APPLICATION NO.	FILING DATE	FIRST NAMED INVENTOR	ATTORNEY DOCKET NO.	CONFIRMATION NO.
10/824,559	04/14/2004	Karsten Kohler	TD 149	6248
27956	7590	08/04/2005	EXAMINER	
KLAUS J. BACH 4407 TWIN OAKS DRIVE MURRYSVILLE, PA 15668			ROYAL, PAUL	
			ART UNIT	PAPER NUMBER
			3611

Office Action Summary

DETAILED ACTION

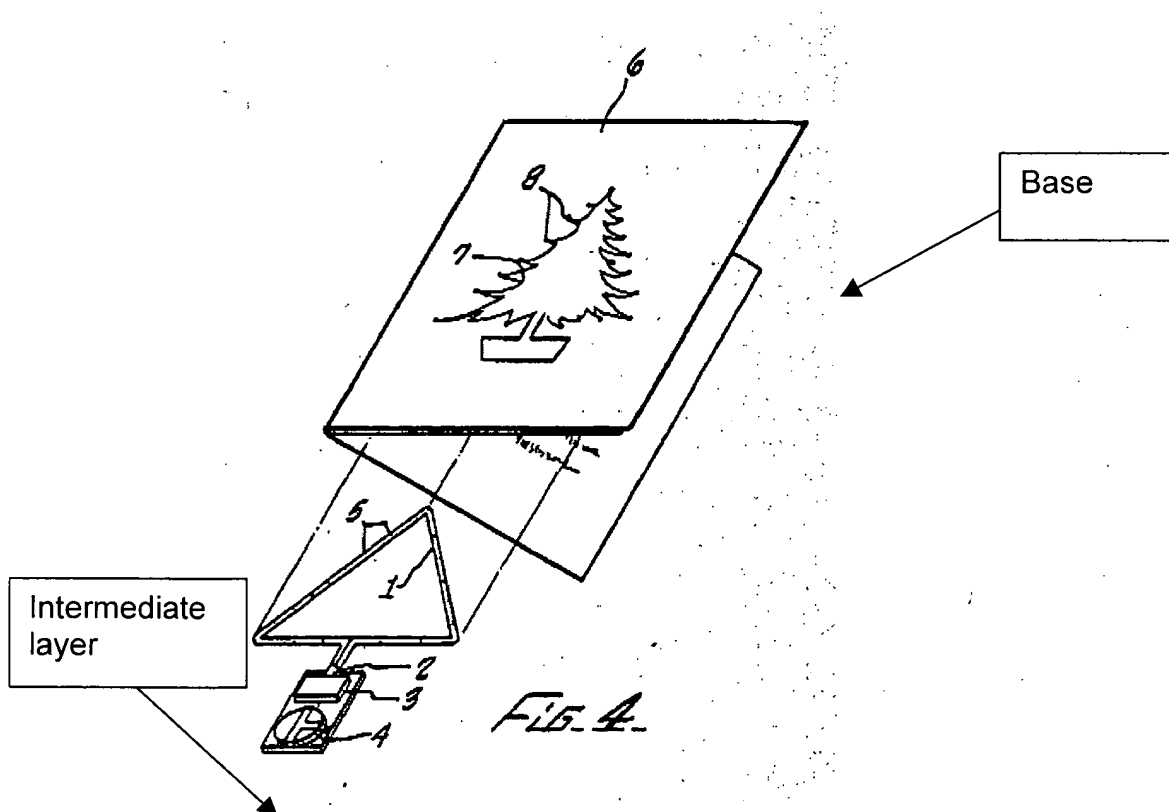
Ku teaches a greeting card with a blinking light apparatus comprising:

a base (Base, see Examiner's annotated Figure 6);

at least one light emitting element (2) disposed on said base (Base);

a cover layer (6);

a power supply (4); and

an operating element/control unit (3).

Note, the power supply, operating element, and light emitter are integrated circuits and appropriate mechanisms such as a battery and a switch, which are shown mounted on an intermediate layer, see Examiner's annotated Figure 4.
